ADDENDUM ONE

Project: **Sullivan County Immunization**

November 11, 2022

This Addendum is part of the Contract Documents for the above referenced project and modifies the original drawings and/or specifications, dated **10/27/22**, as noted below. The bidder shall acknowledge receipt of this Addendum in the place provided in the Bid Form. The published bid date and time shall remain the same.

CASEWORK
ELEVATIONS &
SECTIONS

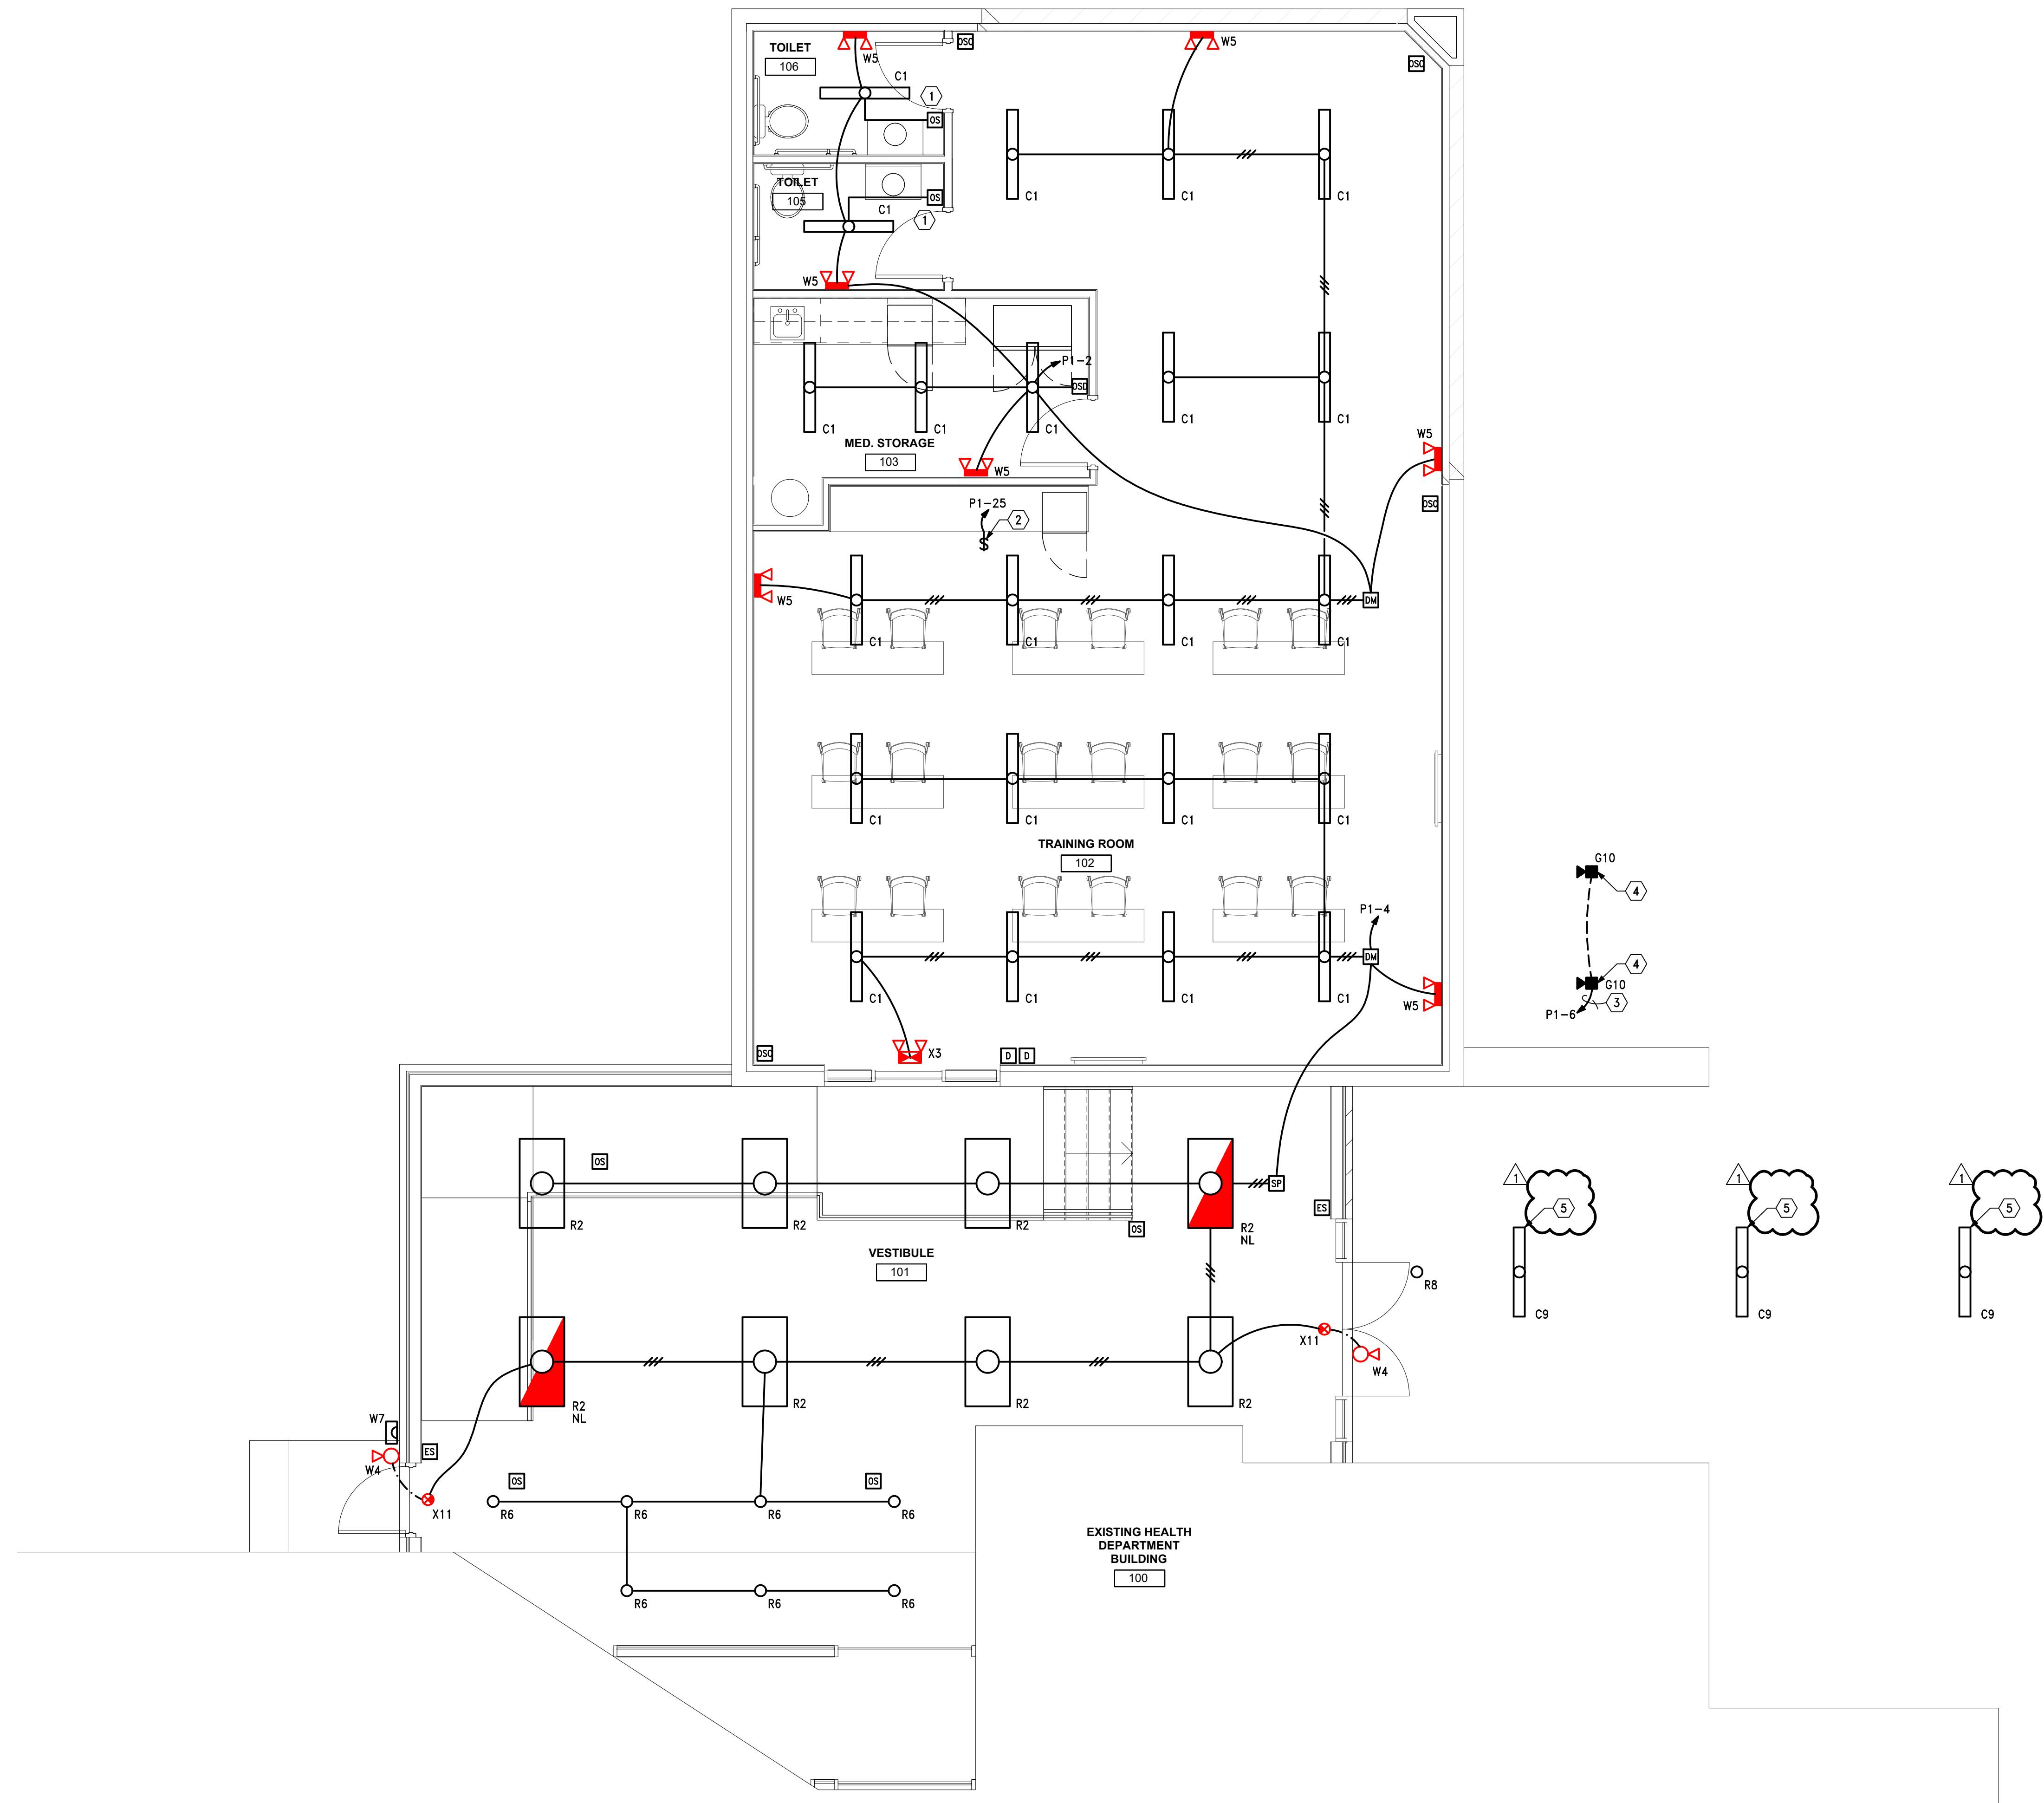
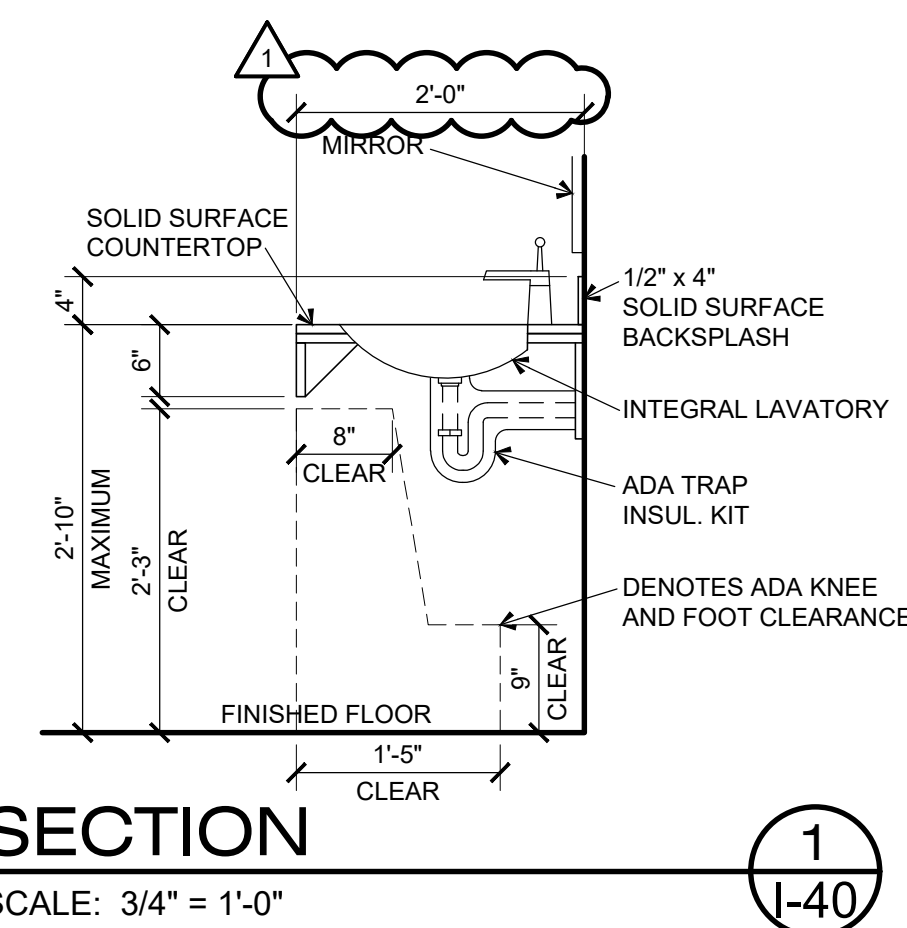
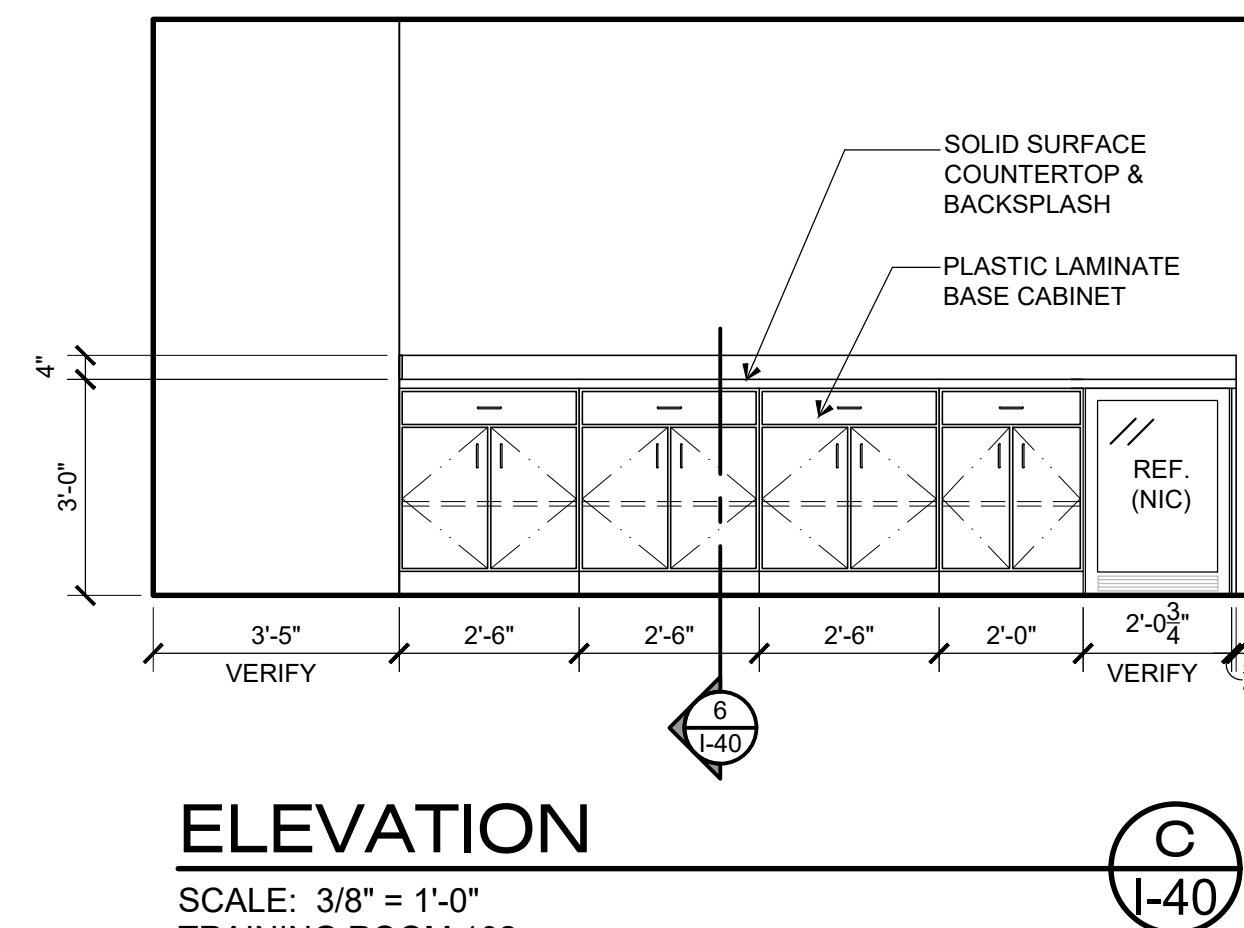
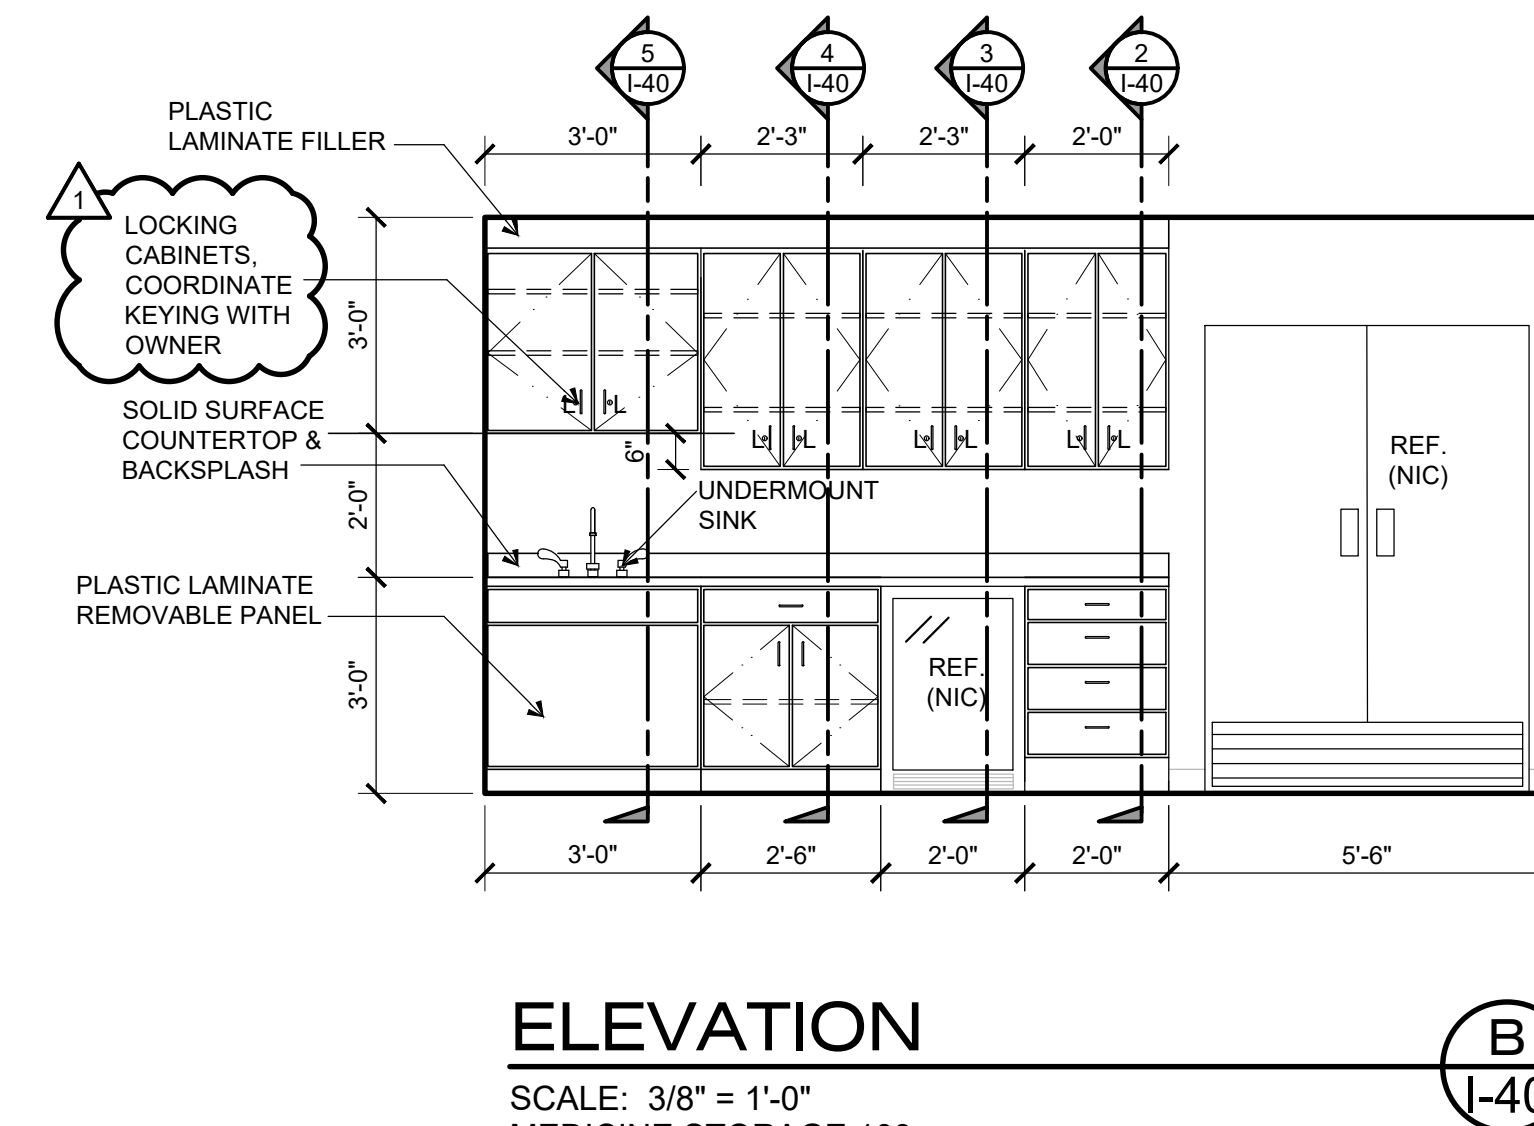
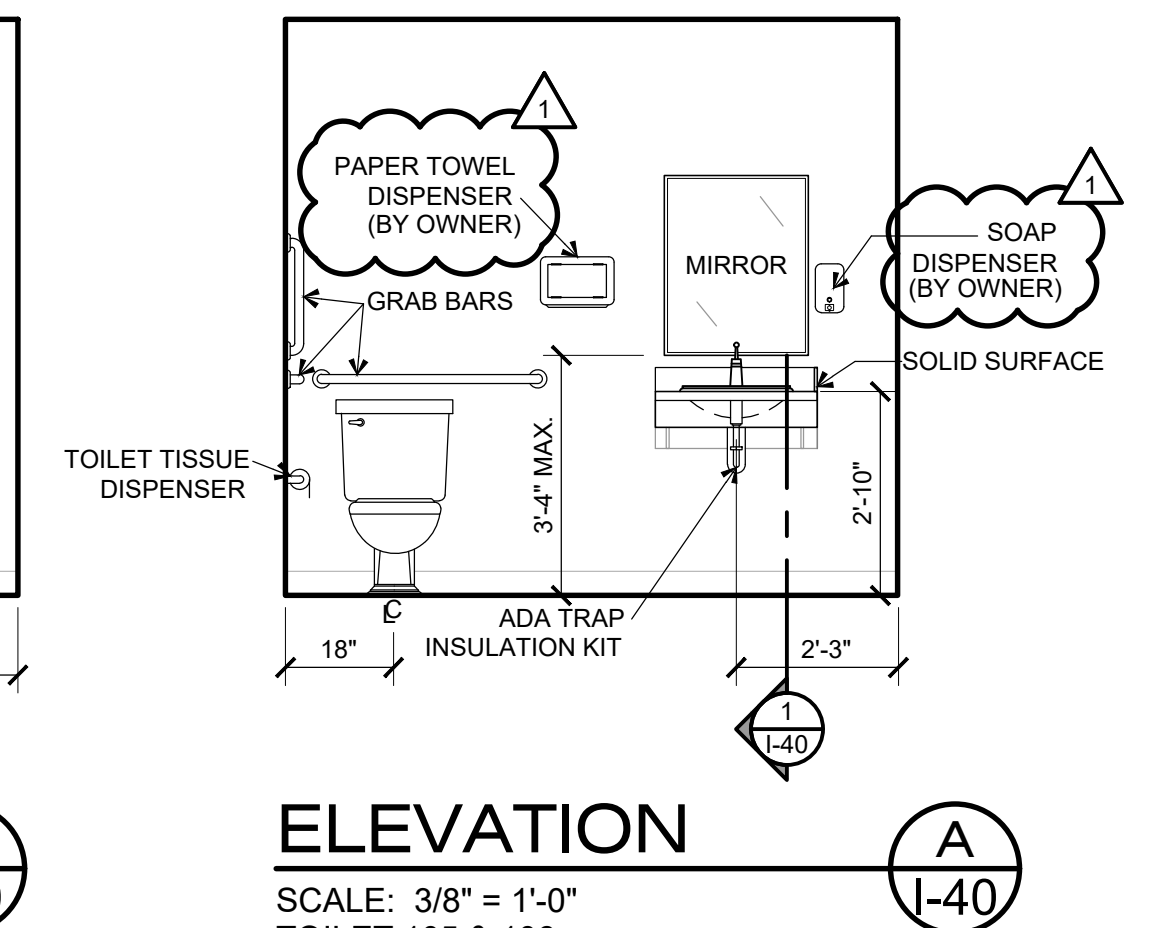
20. **Sheet I-40 Casework Elevations & Sections** – noted cabinet locks, revise toilet accessories.
21. **Sheet E-11 Lighting Plan - Base Bid** – added labels to canopy lights.
